**Re: Landmark at Town Center (#1576564)/Pre-Application Meeting held September 23, 2021**

## Planning and Development Services

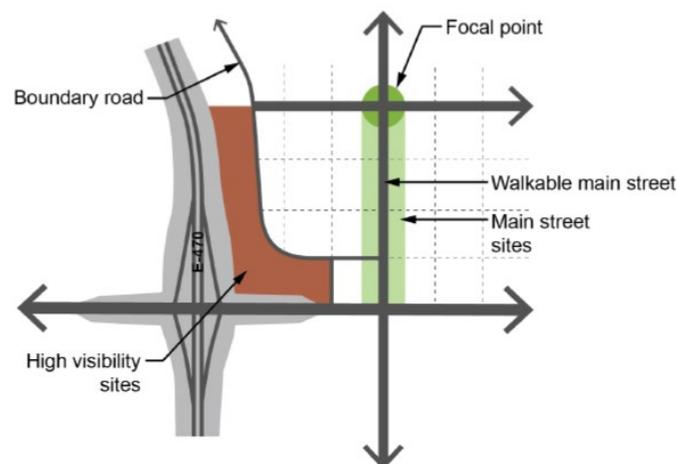
The standards identified and shown in the graphic below must be addressed and illustrated on the Site Plan:

- Focal Point: a point that serves as the center of the area with the highest development density or the most intense activity in the district. This focal point shall be visible from E-470 and is immediately adjacent to the walkable main street element.

**Response:** *The site plan provides a Main Street entry off of the extension of E 5<sup>th</sup> Avenue. It is flanked by parallel parking on each side to enhance the boulevard feel, and terminates into a vehicular roundabout in front of the Leasing/Clubhouse. Building Architecture at the Club will provide an enhanced entry and elevated building design and materials.*

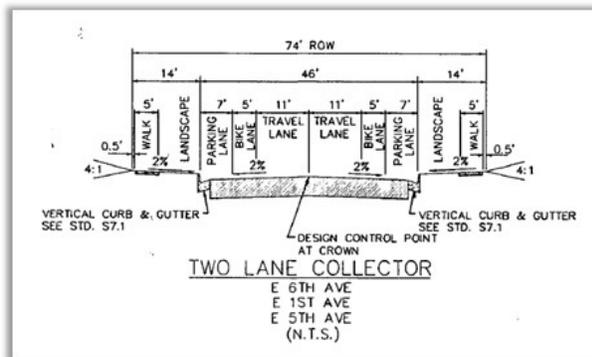
In regards to your second question, I am attaching a picture of the standard section of 6<sup>th</sup> from the west side of the intersection. This is snipped from the Cross Creek CD's (EDN:203136). We would like to see the road continued using the existing southern flow line from the west side using this section. Any sidewalk outside of ROW can be put in a sidewalk easement – meaning no additional ROW besides the corner radius will be required to be dedicated.
